PG&E Letter DCL-15-136

Docket No. 50-275, OL-DPR-80
Docket No. 50-323, OL-DPR-82
Diablo Canyon Units 1 and 2
Response to Requests for Information Related to the Environmental Review of the
Diablo Canyon Power Plant, Units 1 and 2 License Renewal Application – Severe
Accident Mitigation Alternatives (TAC MF4019 and MF4020)

Pacific Gas and Electric Company's Response to October 23, 2015, Nuclear Regulatory Commission Request for Additional Information Related to the Environmental Review of the Diablo Canyon Power Plant, Units 1 and 2 License Renewal Application – Severe Accident Mitigation Alternatives

Environmental Report
 Diablo Canyon Power Plant
Figure F.2-5
 DC03 Fire Contribution to Unit
 1 CDF by Fire Area

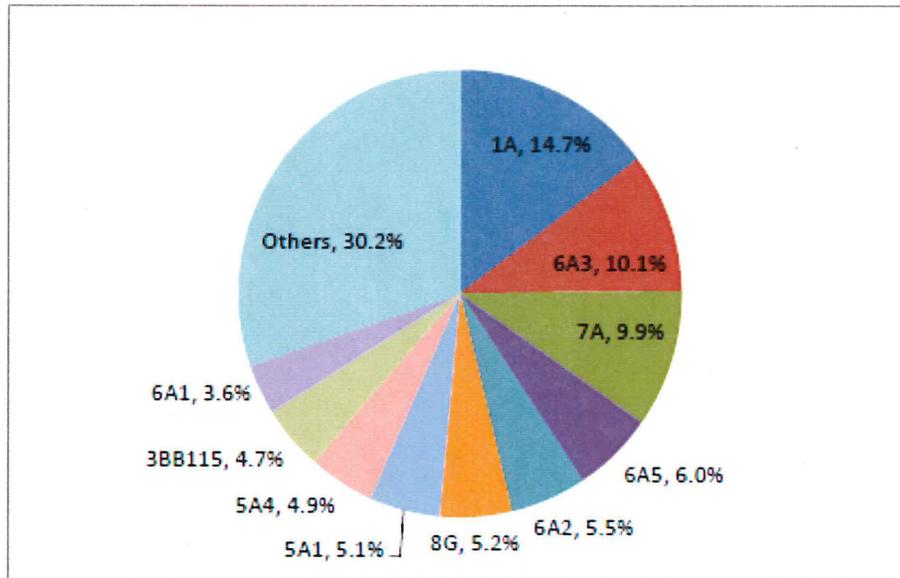
The figures in ER Amendment 2 presenting the contributors to the internal fire and internal flood CDF and LERF (Figures F.2-5 through F.2-8) indicate that the contributions are by initiating event. Confirm that the contributions are by initiating event rather than fire or flood zone or if not, provide the correct description. Also, note that in Figure F.2-5, the contribution from 3BB115, while included in the figure itself, it is not included in the description table. Please add this to the table.

An updated version of Figure F.2-5 is provided in Attachment 1 to this Enclosure and includes the label for fire area 3BB115.
